SERVICE TECHNICAL INFORMATION

ONE POINT REPAIR

REF. NO. : SI-96-018

SUBJECT : CD dropout, speaker box moves

Fig. 1

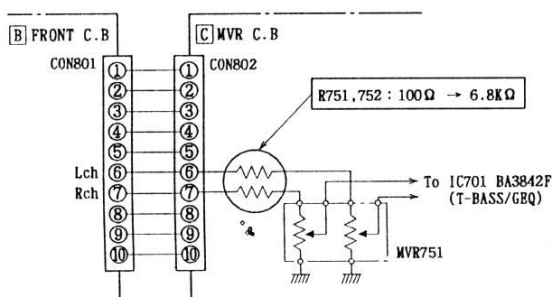
CONTENTS : While playing the CD with T-BASS ON, BBE ON, GEQ ON (Rock or Disco), and with the volume beyond the 10 o'clock position, errors such as CD dropout or movement of the SP BOX occur.

Ref.		Parts No.	REMARK
R751, 752	C-RES, 100Ω-1/10W → C-RES, 6.8KΩ-1/10W	88-118-682-080	Fig-1
C221, 222	CAP, 1μ/50V → CAP, 0.1μ/50V	87-016-247-080	Fig-2
C229, 230	CAP, 10μ/50V → CAP, 2.2μ/50V	87-010-495-010	Fig-2

REMEDY : Replace the following parts.

Fig-3

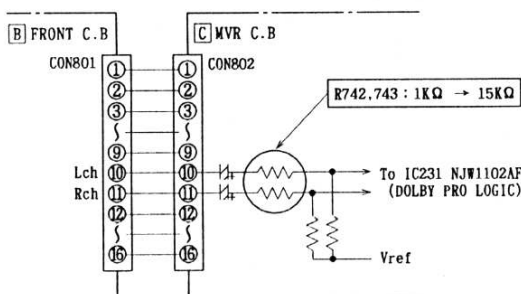
Ref.		Parts No.	REMARK
R751, 752	C-RES, 1KΩ-1/10W → C-RES, 15KΩ-1/10W	88-190-153-010	Fig-3
C221, 222	CAP, 1μ/50V → CAP, 0.22μ/50V	87-010-545-010	Fig-4
C229, 230	CAP, 10μ/50V → CAP, 2.2μ/50V	87-010-495-010	Fig-4
